# SERVICE BULLETIN

## SB-082317 REV A

SUBJECT: Starboard (STBD) Forward Bulkhead pass through for Main Wire Harness

AIRCRAFT AFFECTED: MODEL: ICON A5

Figure 1: Grommet Placement (Green line)

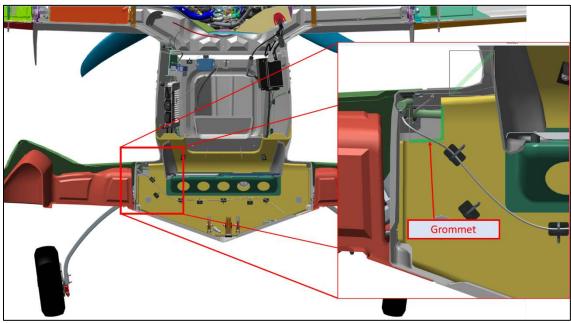
ICON is committed to designing, manufacturing, delivering, and supporting a high quality Light Sport Aircraft, providing a level of safety well beyond expectations. During routine maintenance of the aircraft, it was discovered that the grommet was missing on the STBD forward bulkhead pass through, Figure 1. The bulkhead pass through surface caused chafing of the main wire harness causing intermittent failure

**REQUIRED ACTION:** 1) Visually inspect for STBD forward bulkhead grommet –

A) If the grommet <u>IS</u> in place – Operation of the aircraft can continue. Compliance with this Service Bulletin can be recorded as complete via inspection.

B) If the grommet is **NOT** in place - Determine if the main wiring harness is touching the STBD forward bulkhead at the pass through

- If the main wiring harness is <u>NOT</u> touching the STBD forward bulk head at the pass through - Install grommet within 10 hours of flight time.
- II) If the main wiring harness <u>IS</u> touching the STBD forward bulk head at the pass through Visually Inspect wiring harness expandable sleeving protection and underlying wiring for damage where the harness contacts the bulkhead
- a. If no damage is evident It is permissible to relocate the aircraft to the nearest maintenance facility and within the next 2 hours of operation install the grommet
- b. If there <u>IS</u> damage to the protective sleeving and/or wiring Immediately discontinue operation of the aircraft, install grommet, assess the damage and report findings to ICON CS&S for repair instructions.

Figure 2: Burned Wires

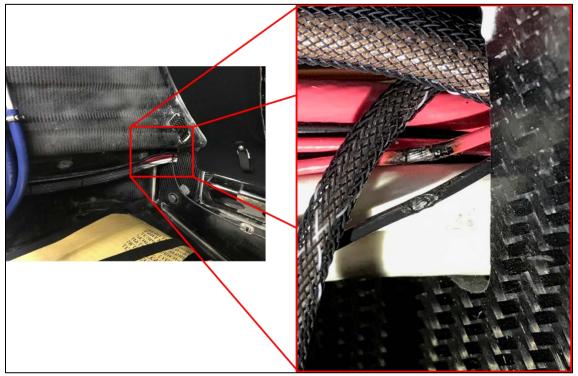
of the fuel pump. This also caused several failures of the fuses and eventually the wires were burned, Figure 2.

Figure 3: Grommet Install & Ty-Rap Locations

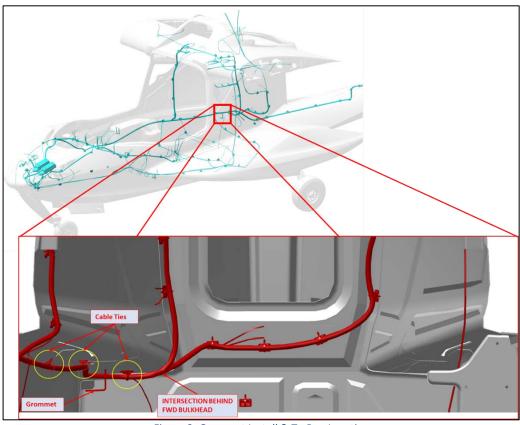
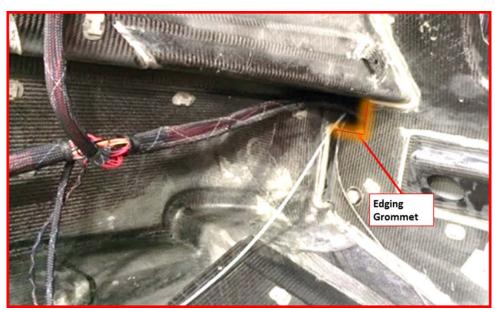
#### Instructions to install grommet, Figure 3 & 4:

- 1. Bond Plastic edging grommet to FWD Bulkhead Pass Through
  - a. Wipe bonding surface with isopropyl alcohol discarding cloth after each pass
  - b. Lightly abrade bonding surface using 80-100 grit sandpaper abrade an area approx.  $\frac{1}{4}$ " beyond the bonding surface.

NOTE: abrade carbon surface just enough to remove surface gloss.

- c. Vacuum the area abraded to remove any remaining particulate residues
- d. Wipe bonding surface again with isopropyl alcohol discarding cloth after each pass
- 2. Bond plastic edging grommet (MS21266) with CB200 or MA830 adhesive on STBD FWD bulkhead pass through as shown. Follow manufacturer's instructions for cure time.
